## RESPONSE TO REQUEST FOR ADDITIONAL INFORMATION

### APR1400 Design Certification

Docket No. 52-046

**RAI No.:** 540-8729  
**SRP Section:** 08.02 - Offsite Power System  
**Application Section:** 8.2  
**Date of RAI Issue:** 02/21/2017

**Figure 1 – Typical OPC Detection and Protection Sequence Diagram (with non-Class 1E detection features)**

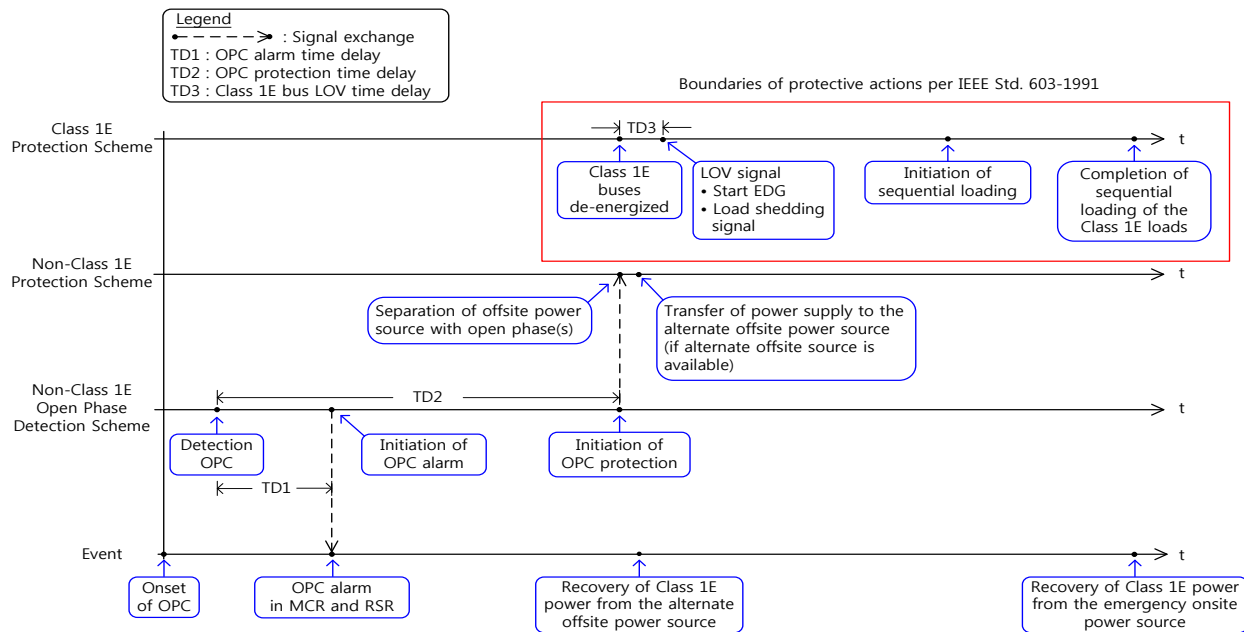
**Item 1.c) Protection scheme should comply with applicable requirements including single failure criteria for ESF systems as specified in 10 CFR Part 50, Appendix A, GDC17, and 10 CFR 50.55a(h)(2) or 10 CFR 50.55a(h)(3), which require compliance with IEEE Std 279-1971 "Criteria for Protection Systems for Nuclear Power Generating Stations" or IEEE Std 603-1991, "Standard Criteria for Safety Systems for Nuclear Power Generating Stations." RG 1.153, "Criteria for Power, Instrumentation, and Control Portions of Safety Systems," provides additional guidance on this topic.**

**If protective features are provided in a non-Class 1E system only, a failure of the non-Class 1E scheme should not preclude the onsite electrical power system from performing its safety function given a single failure in the onsite power system.**

As depicted in Figure 1, the APR1400 overall design features to address an OPC will encompass non-Class 1E and Class 1E systems. Considering the application of IEEE Std. 603-1991, only the Class 1E portion of the design features is subject to the applicable requirements, including the single failure criteria for ESF (Class 1E) systems. Compliance with the requirements for the Class 1E system is addressed in DCD Tier 2, Subsections 8.3.1.1.2 and 8.3.1.2.2. If the COL applicant chooses an OPDP system bounded only for the Class 1E system, the OPDP system as a whole should comply with applicable requirements, including single failure criteria for ESF (Class 1E) systems.

If a failure occurs in the non-Class 1E part of OPC detection and protection features (including a failure of redundant detection features), the failure does not preclude the onsite electric power system from performing its safety function given a single failure in the onsite power system based on the following.

- The worst case single failure in the non-Class 1E portion of the detection and protection features is spurious operation of the detection and protection feature. This condition causes unwanted separation of the offsite power source formerly supplying safety loads. As a result, the Class 1E buses will lose electric power unless the offsite power is transferred to the alternate offsite source. And the loss of voltage condition will automatically initiate operation of the emergency power source for safety loads and maintain the ability of supplying electric power to ESF loads.

- There is no physical or functional interface or interdependency between a failure in the non-Class 1E features and protective actions of the Class 1E features. No single point vulnerability exists between the non-Class 1E and Class 1E features owing to proper physical separation in accordance with IEEE Std. 384-1992 as endorsed by RGs 1.32 and 1.75.

- The Class 1E protection scheme is redundant and independent, so the safety function of the Class 1E system is not compromised given a single failure in the onsite power system.

- Therefore, a failure in the non-Class 1E portion of the OPC detection and protection features does not preclude the onsite electric power system from performing its safety function given a single failure in the onsite power system.
